**BEFORE THE BOARD OF ZONING
ADJUSTMENT OF THE DISTRICT OF
COLUMBIA**

**APPEAL OF 2101 CONNECTICUT AVENUE
COOPERATIVE APARTMENTS, INC. FROM A
DETERMINATION OF THE ZONING
ADMINISTRATOR PERTAINING TO A PROPOSED
REAR ADDITION TO 2014 KALORAMA ROAD,
NW, WASHINGTON, DC 20009
SQUARE 2537, LOT 0301 (R-5-B)**

Re: Zoning PDRM – 2014 Kalorama Road, NW – Subject Property

ZONING ANALYSIS 2012 KALORAMA RD, NW

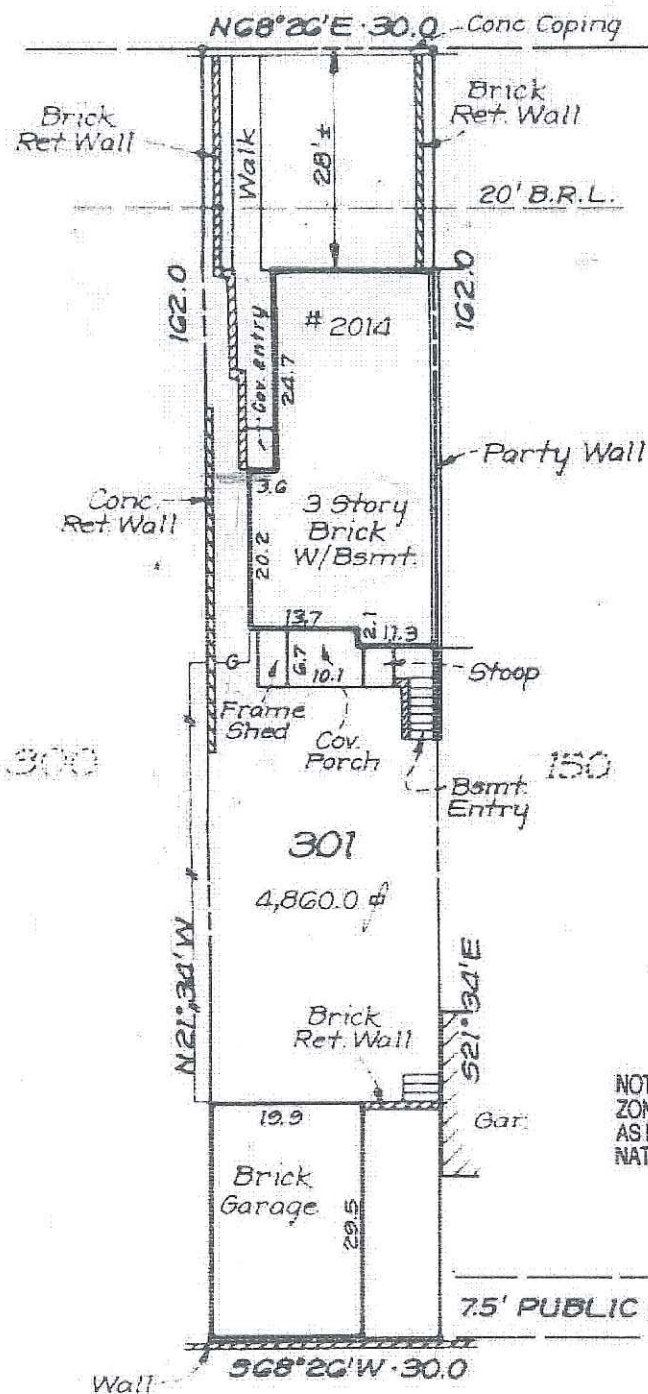
The Zoning Analysis shows a rear parking lot with a width of 20-feet and a length of 30-feet. Even just three parking spaces would require a width of 24-feet. As designed, the Project does not meet this standard, and the dimensions provided only allow for three, 6.6-foot wide parking spaces, falling short of the required 8-foot width. Accordingly, only two parking spaces could be legally provided on the surface parking lot, meaning that the Project could not even replace the three parking spaces that exist on the 2014 Lot today. For this reason, the proposed parking fails to meet the standards of the Zoning Regulations.

As stated above, the Determination includes by reference a "Zoning Analysis." However, a review of the Zoning Analysis establishes that it includes mistakes and does not contain information necessary for the Zoning Administrator to make his determination. First, the Zoning Analysis is labeled "2012 Kalorama" and identifies the property as being located at Square 2537, Lot 0150. The subject Property is located at 2014 Kalorama Road, and is recorded at Square 2537, Lot 301, therefore, this information is incorrect. This raises questions as to whether the additional information provided related to square footage, lot occupancy, height, etc. is inaccurate as well. Therefore, due to these clear, factual errors, it is not certain that the Zoning Administrator reviewed a correct Zoning Analysis for 2014 Kalorama, and accordingly, any Determination made about the zoning for 2014 lacks support.

Second, the Zoning Analysis lacks crucial information necessary to show compliance with the Construction Code and support the Zoning Administrator's decision. Specifically, the Zoning Analysis does not comply with the requirements for a "Zoning Compliance Review Data" set forth in section 106.1.12 of the District's 2008 Construction Codes codified at Title 12A-DCMR §§ 101A *et seq* (the "Construction Code"). Generally, this regulation requires applications for zoning compliance review include "plans drawn to a scale indicated numerically as well as depicted graphically, showing the orientation of the property as to true North" and showing "the shape and location in plan of all existing and proposed structures, fully dimensioned, including orientation and distances to lot lines so as to define without ambiguity the dimensions and location of said structures." This information is necessary for the Zoning Administrator to determine the Project's compliance with the Zoning Regulations. A review of the Zoning Analysis establishes that this document fails to meet all of these requirements. In particular, the Zoning Analysis lacks almost all dimensions, an identification of the front or rear portions of the property, notation of heights, a unit count or even an orientation to true North. Rather, the Zoning Analysis appears to be conceptual designs accompanied by unsupported conclusions that the Project satisfies the FAR and lot coverage requirements. Such a document does not allow for a determination of Code compliance.

BOUNDARY & PLANIMETRIC SURVEY
OF THE COMMON LINES BETWEEN
LOTS 300 & 301 - SQUARE 2537
2101 CONNECTICUT AVENUE, NW &
2014 KALORAMA ROAD, NW
WARD 1 ANC 1C DISTRICT OF COLUMBIA

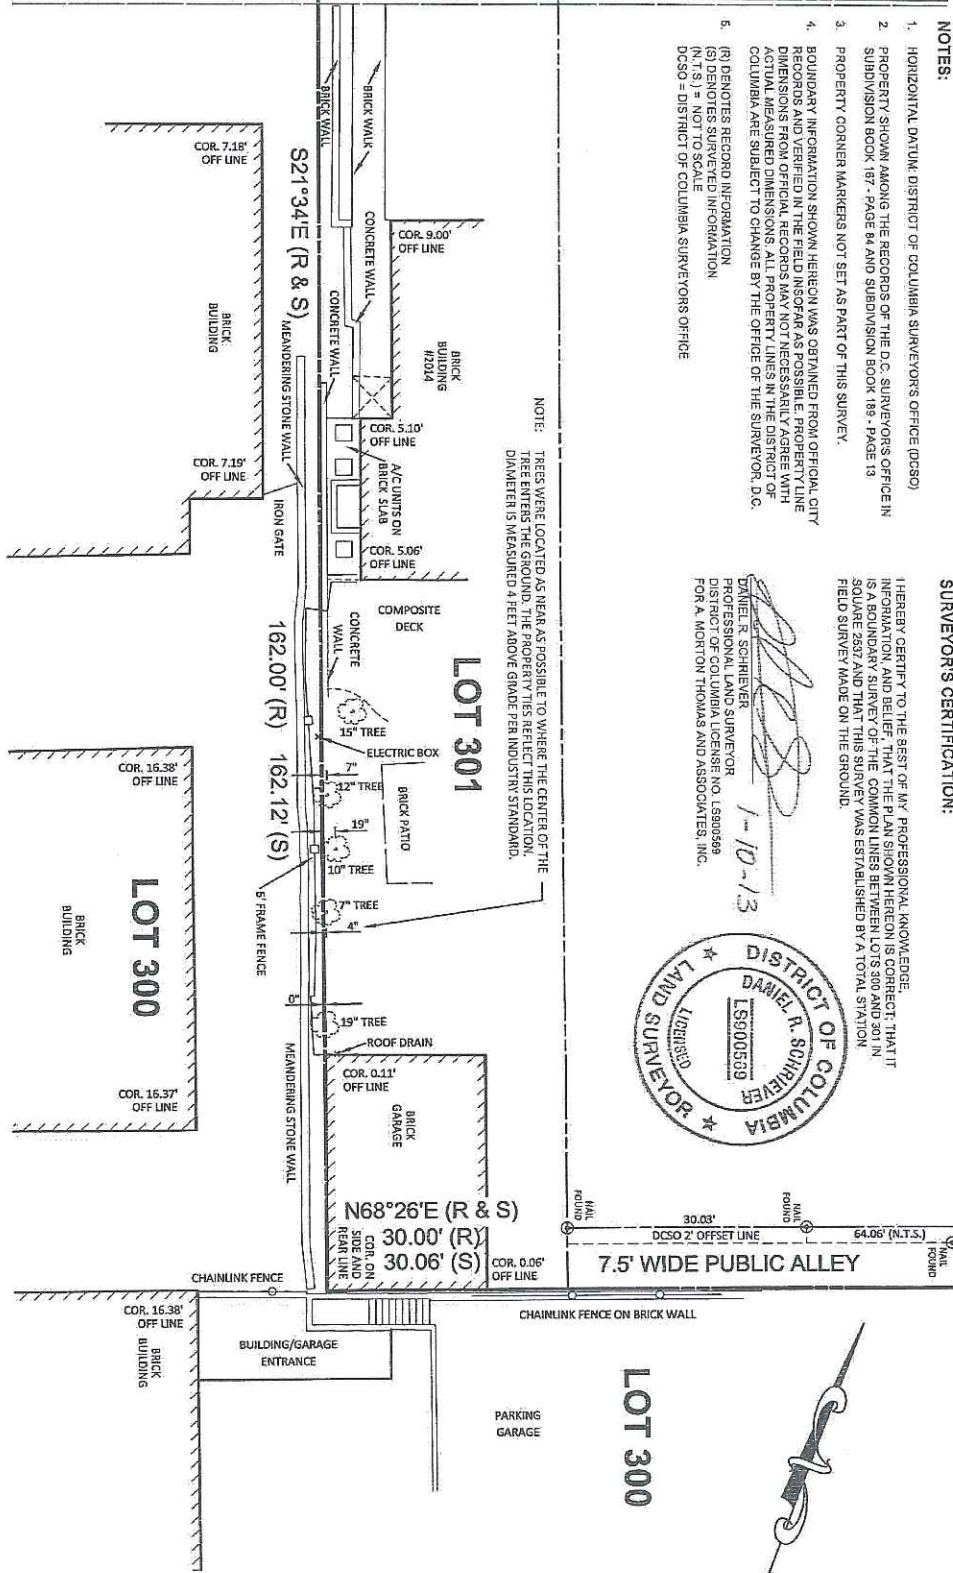
² Although not addressed in the Determination, the Survey as Exhibit “B”, clearly shows up to three trees on the property line between the 2014 Lot and the 2101 Residence. These trees are jointly owned by the Developer and the Cooperative as common property and cannot be taken down without approval by the Cooperative. Due to the fact that the Cooperative will not agree to

remove those trees, and the Project presented to the Zoning Administrator requires the removal of these trees to construct the design as proposed, the Project cannot be legally constructed and must be redesigned.

Parking

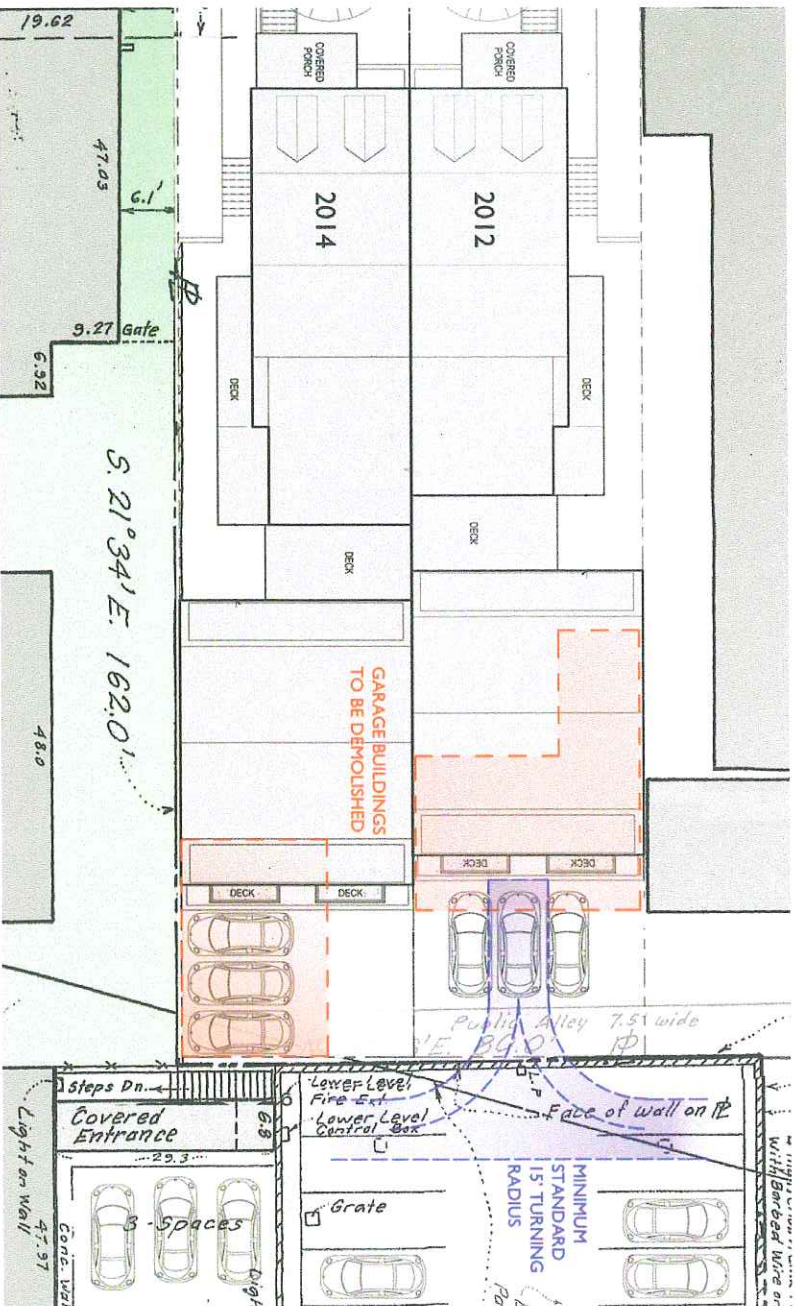
- Ingress/Egress impossible for vehicles and passengers.
- Will not conform to the Zoning Administrators requirements.
- Not legal spaces.
